TRANSPORT IMPACT ASSESSMENT

PROPOSED MULTIPLE DWELLINGS

203 ESPLANADE, REDLAND BAY

(RESPONSE TO INFORMATION REQUEST DATED 2 JULY 2025)

FIGURE 4.7 – B99 VEHICLE MANOEUVRING

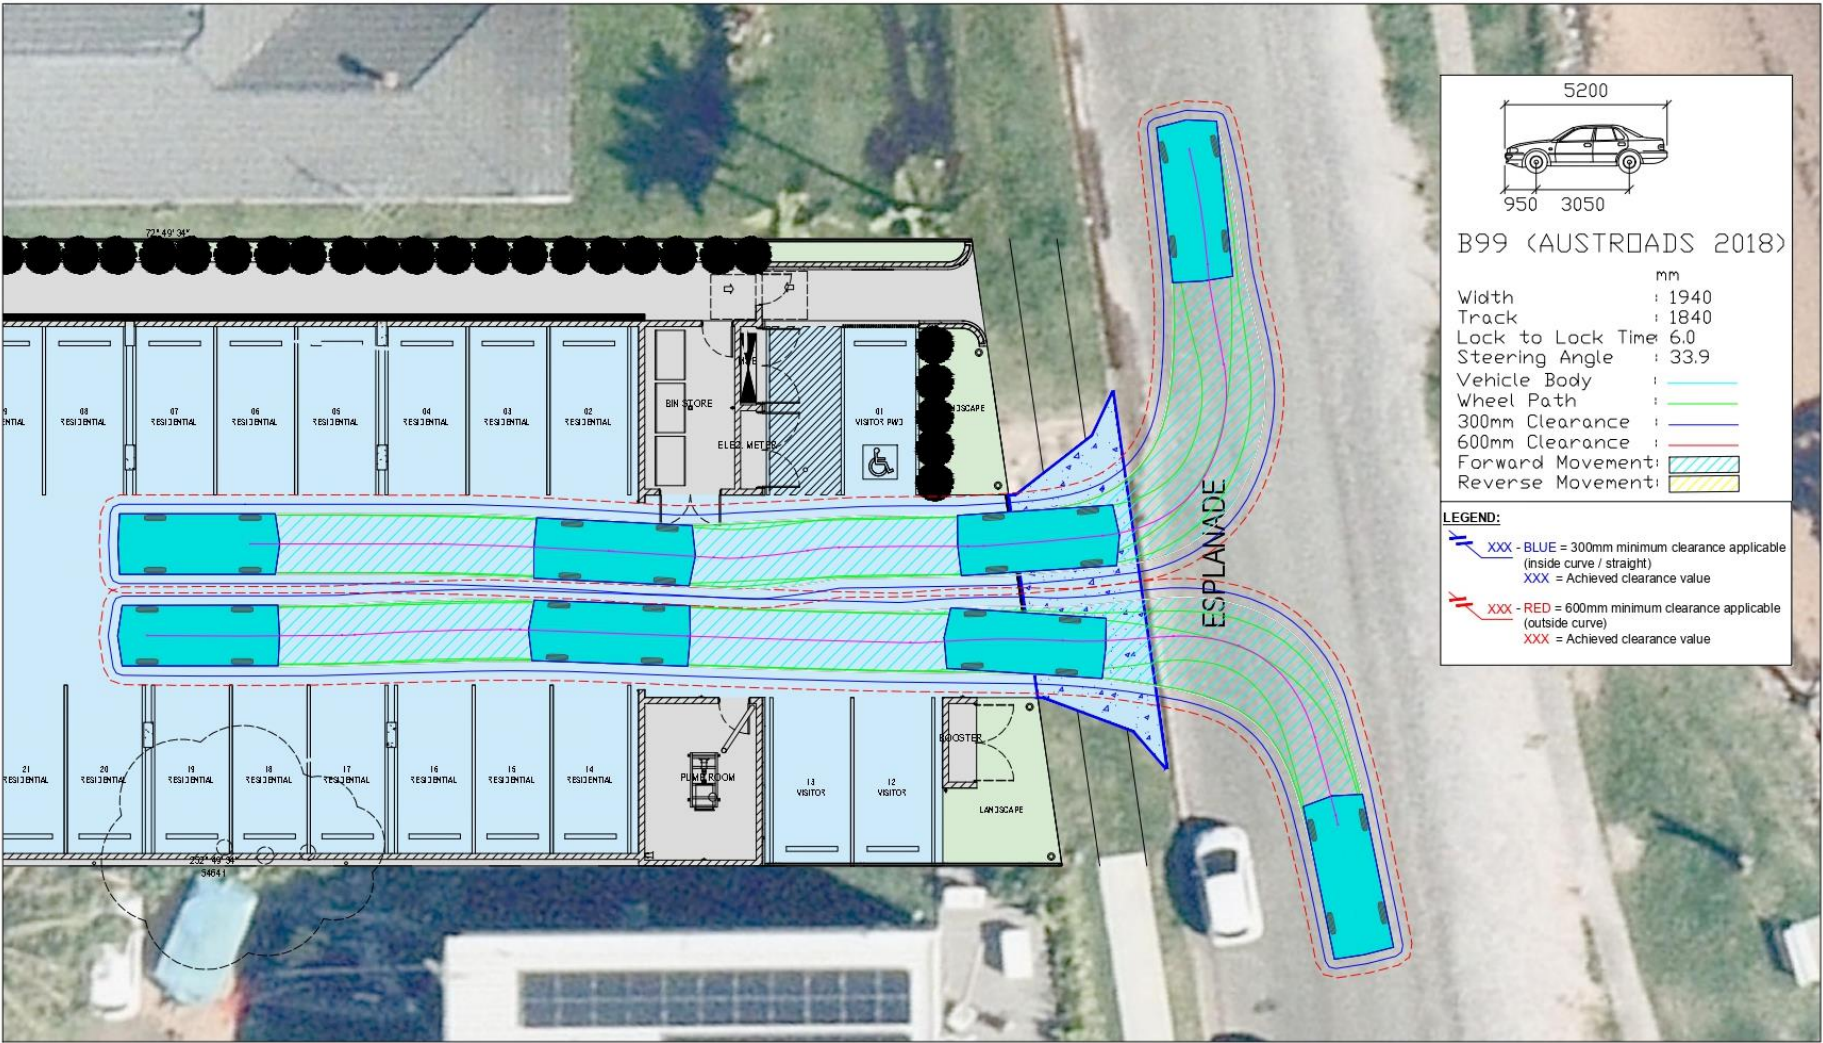
6. The swept paths shown in the Traffic Impact Assessment (TIA) by rytenskild Traffic Engineering (24291 V1, dated 24 January 2025) are inconsistent with the architectural drawing Ground Level by think tank architects (36-24 TP101 Rev. 6, dated 25 March 2025). The following issues arise as a result of the inconsistencies and will need to be revised:

- Swept paths shown in the TIA for access to all parking spaces.
- Access by a design vehicle (car) has not been demonstrated for parking space no. 11 (western end) due to the blind aisle now not extending past the parking space sufficiently to enable turning manoeuvres that would not be considered excessive.
- The driveway length between the property boundary and the car park gate, and positions of the visitor spaces, result in the queuing area not meeting the standards required for queue length and vehicle manoeuvring.

Provide a revised design that accommodates access to all resident parking spaces by the design vehicle, queued vehicles on-site, and enables visitor space parking manoeuvres and waste collection vehicle manoeuvres to be conducted on-site while avoiding conflict with vehicles and pedestrian activities. In doing so, demonstrate compliance with performance outcomes PO8, PO9, PO18, and PO20 of the transport, servicing, access and parking code.

The TIA and associated swept path analysis have been updated to align with the latest architectural plans. Access arrangements have been reviewed, and the aisle adjacent to space 11 has been widened to 6.5 metres, allowing improved manoeuvring for vehicles using the space.

Sufficient setback is provided from the property boundary to enable at least two vehicles to queue clear of the frontage, which is considered satisfactory given the scale of the development.

It is acknowledged that visitor parking has been positioned within the queuing area of the site access. This arrangement is considered acceptable given the development is expected to generate a low level of visitor demand and a low turnover from the provision of only three (3) visitor spaces. On the rare occasion that a visitor is departing as a vehicle is entering, there is adequate space for a vehicle to wait momentarily within the driveway clear of traffic along the Esplanade. The inclusion of visitor parking within access queuing areas is common for developments of this scale and nature and is not expected to adversely impact the operation of the site.

FIGURE 6.1 – SWEEP PATH OF A REAR LOADING WASTE COLLECTION VEHICLE (WCV)

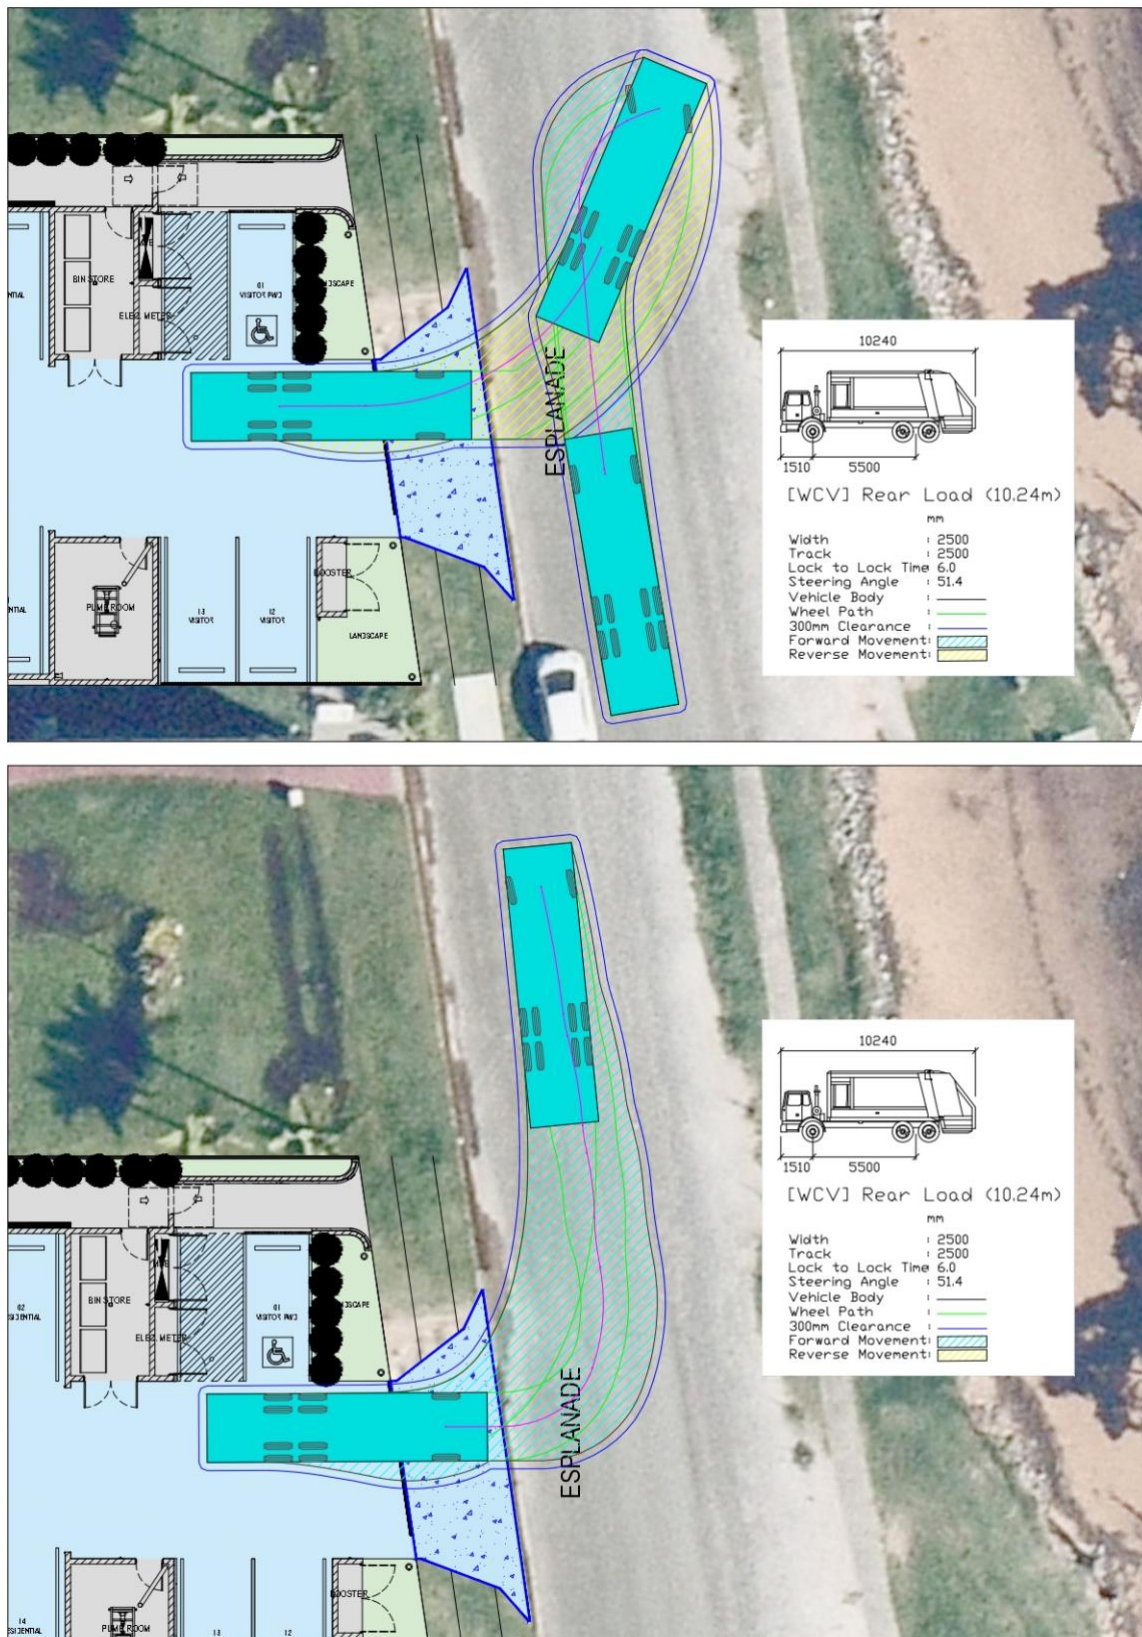
4. The location of the waste bulk bin storage area shown on the architectural drawings is of a suitable size for the number of bins anticipated to be required for the proposed development. The bins are unable to be serviced on-site by a waste collection vehicle (WCV) as the clearance between the driveway and Level 1 is less than that required by WCVs. Provide a revised design that enables a WCV to service the bulk waste bins within the site boundaries. In doing so, demonstrate compliance with performance outcomes PO15 of the infrastructure works code, and PO20 of the transport, servicing, access and parking code.

The proposal provides sufficient length within the site frontage to accommodate a rear-loading Waste Collection Vehicle (WCV) standing wholly within the site during servicing operations. A rear-loading WCV requires an overall operating length of approximately 12 metres, comprising a 10.5 metre vehicle and an additional 1.5 metres at the rear for bin lifting operations.

The swept path assessment confirms that a WCV can reverse onto the site, undertake waste collection activities, and exit in a forward gear without overhanging the kerb or impeding traffic on the Esplanade. Given the infrequent and short-duration nature of waste collection activities, the proposed arrangement is considered satisfactory.
